Memo

To: Cranston City Plan Commission
From: Joshua Berry, AICP – Senior Planner / Administrative Officer
Date: October 20, 2021
Re: **Minor Subdivision without street extension - Preliminary Plan**
“Cosmo Plat – Replat of Garden Park No. 3 Lots 75-78”

Location: 175 Vallette Street, AP 11, Lot 1599

PROPOSED SUBDIVISION PLAN

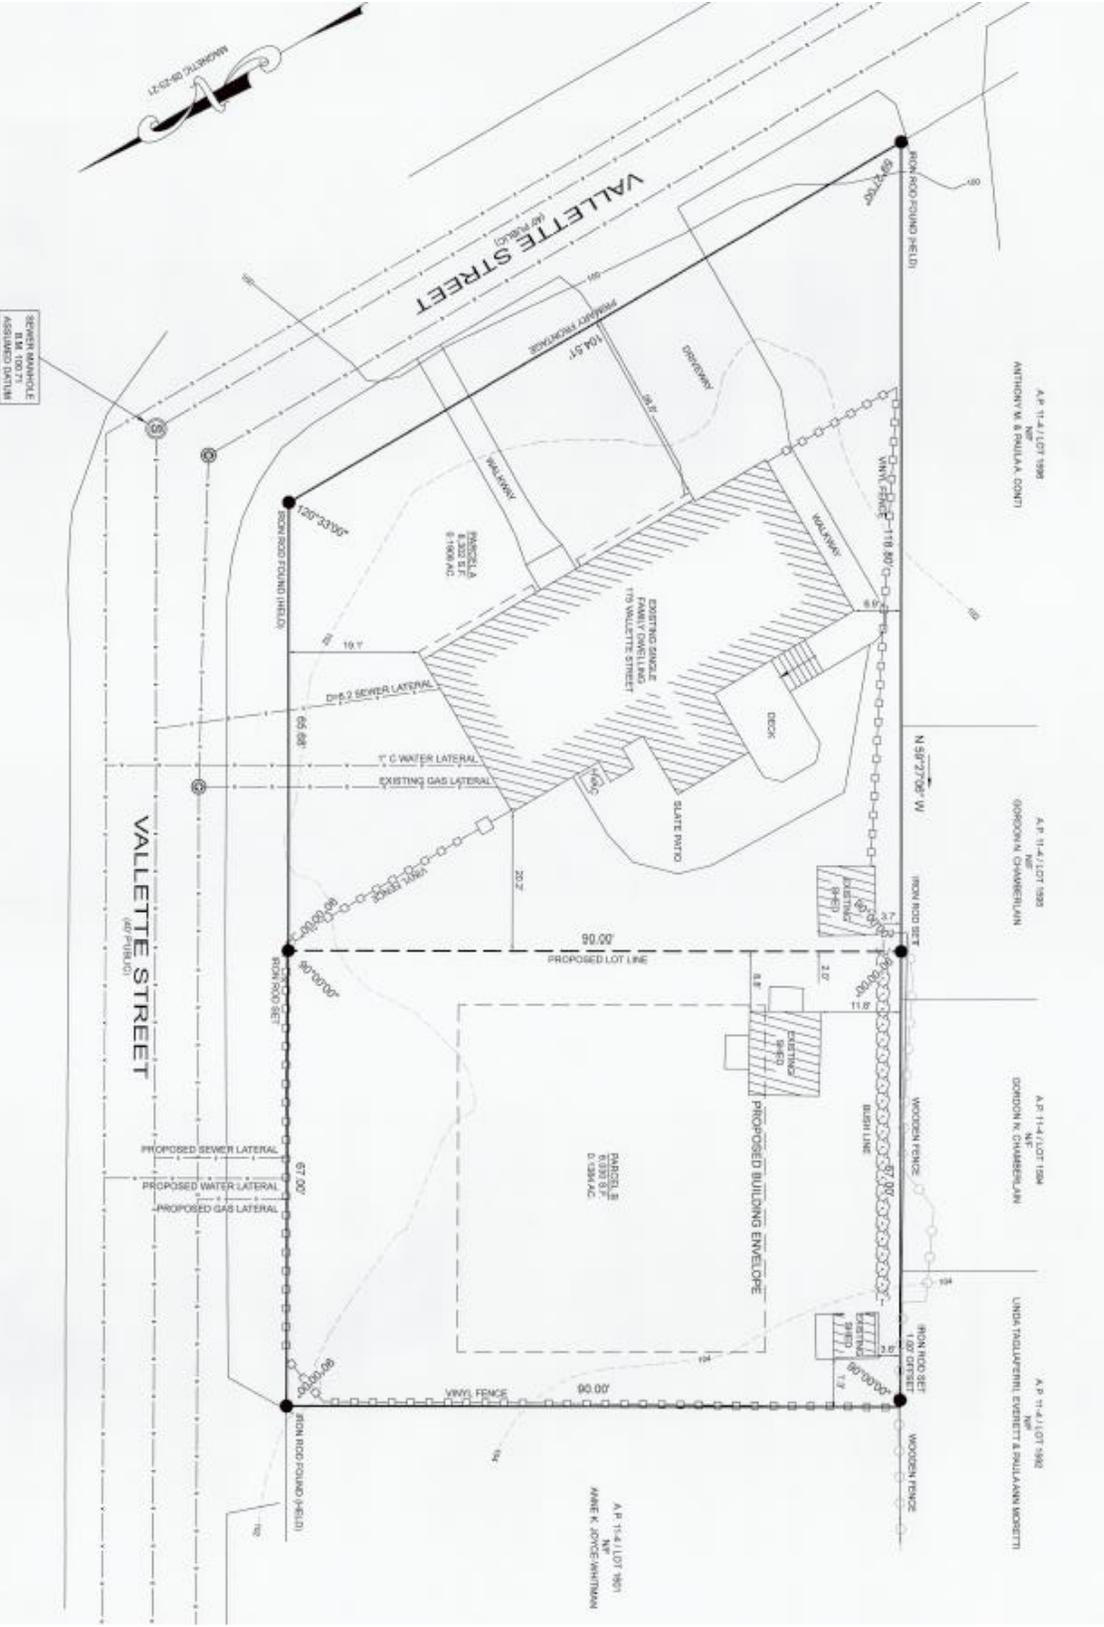
Staff has no concerns with the application and the resulting density on the site. This application provides an opportunity for infill development in Eastern Cranston in a manner that fits with the surrounding neighborhood, which is consistent with the Comprehensive Plan land use and housing policies. The existing fence will need to be removed and the shed that is closest to the proposed lot line will need to be removed or relocated to comply with the new building setback.

The applicant has corresponded that they plan to extend the granite curbing at the frontage of 175 Vallette Street along the frontage of the Parcel B as well (except for the driveway of course). As

there is no development plan showing this, staff has incorporated the continuation of the granite curbing into the conditions of approval.

1. The applicant shall remove or relocate the existing shed so that no new nonconformity is created by the proposed lot line.
2. The applicant shall install granite curbing along the frontage of the lots where it does not already exist, except as to allow for a driveway for Parcel B.
3. Payment of the Eastern Cranston Capital Facilities impact fee in the amount of \$593.46 (1 new unit) must be submitted at the time of final plat recording.
